# SERVICE No. 573 BULLETIN

"Modification DOA EA-1 Approved"

February 8, 1978

Subject: Wing Fuel Tank Cap Modification

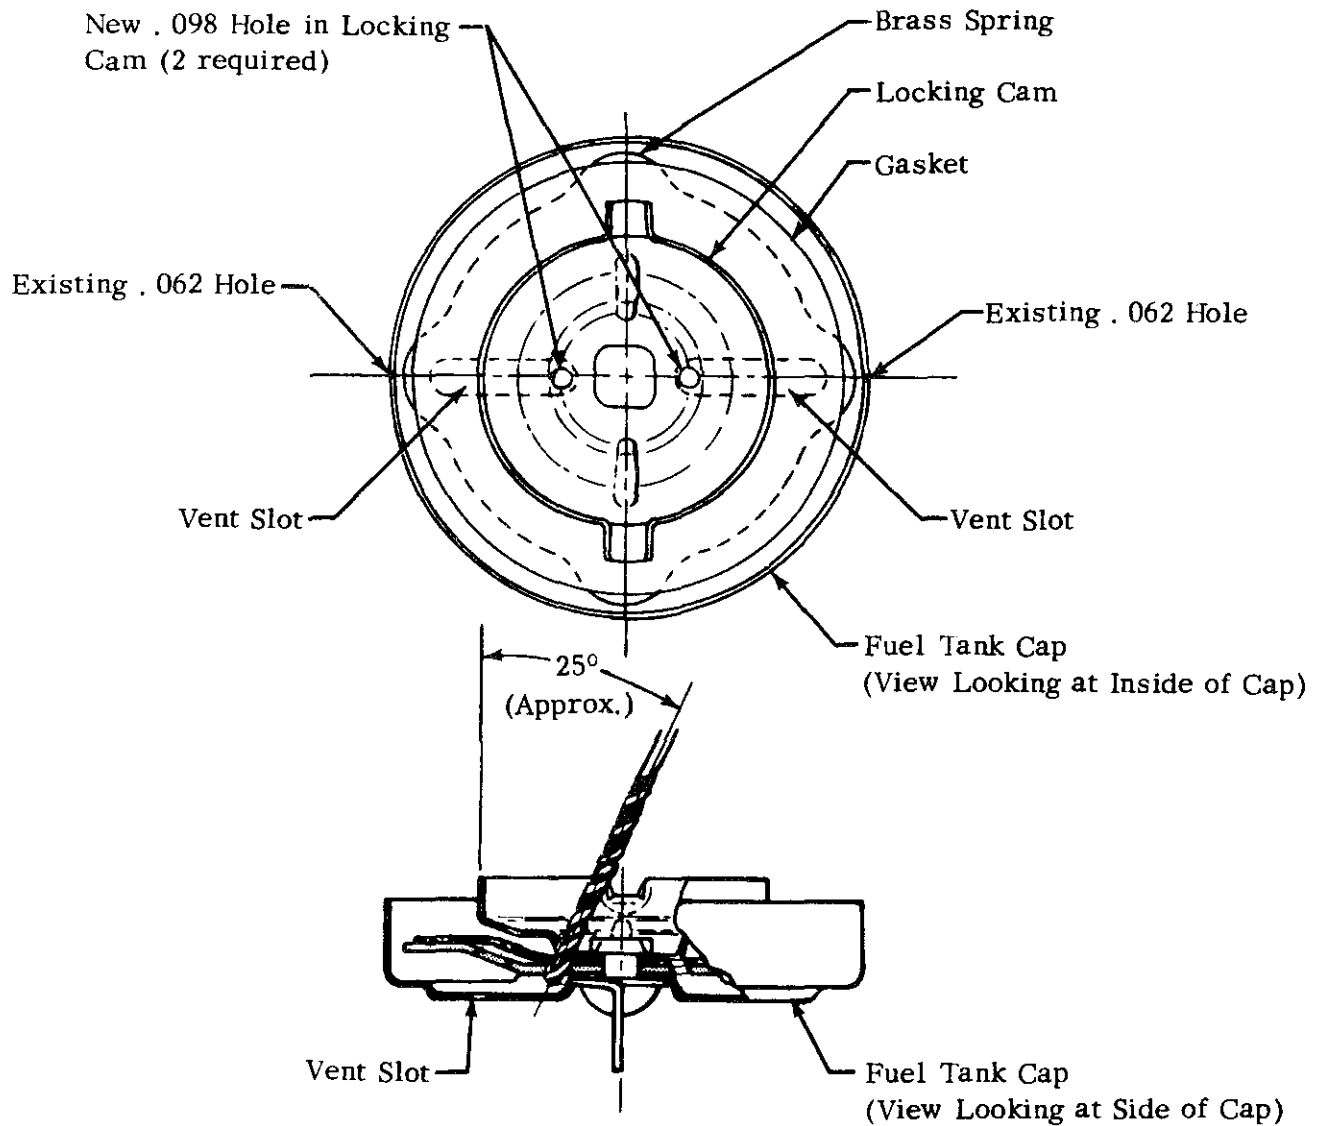
Purpose: Piper Service Bulletin No. 522 dated September 28, 1976 referred to a condition wherein inadequate fuel tank venting could result in fuel tank collapse, and provided instructions to drill two (2) .062 in. vent holes in the fuel tank cap.

A recent fuel tank collapse was attributed to inadequate venting, caused by obstruction of the cap vent holes (installed per above referenced Service Bulletin). Accumulation of foreign material (corrosion, dirt, ice, etc.) inside the cap "sealed off" the cap internal vent slots.

This service release provides instructions to drill two additional vent holes in the cap assembly to insure adequate venting -- in the event that the present vent slots (located in the cap locking cam plate) are obstructed and recommends cleaning and inspecting present vent slots.

1. Remove fuel tank caps from wings and rework caps as follows:
  - a. Locate and mark center of two .098 holes on locking cam of cap as shown. Use existing .062 vent holes to index location of new .098 holes.
  - b. Drill two .098 holes ( $\pm 40$  drill) through locking cam. Angle drill to intersect end of vent slots as shown. **CAUTION: Do not allow drill to go through top cover of cap.**
  - c. Insert .032 wire in existing .062 holes. End of wire will be seen in new .098 holes if holes were correctly drilled.
  - d. With .032 wire in .062 holes, slide wire back and forth to loosen any corrosion or dirt that may be in the vent slots. Clean cap thoroughly with compressed air.
2. Reinstall reworked fuel tank caps and make proper Logbook entry of Service Bulletin 573 compliance.
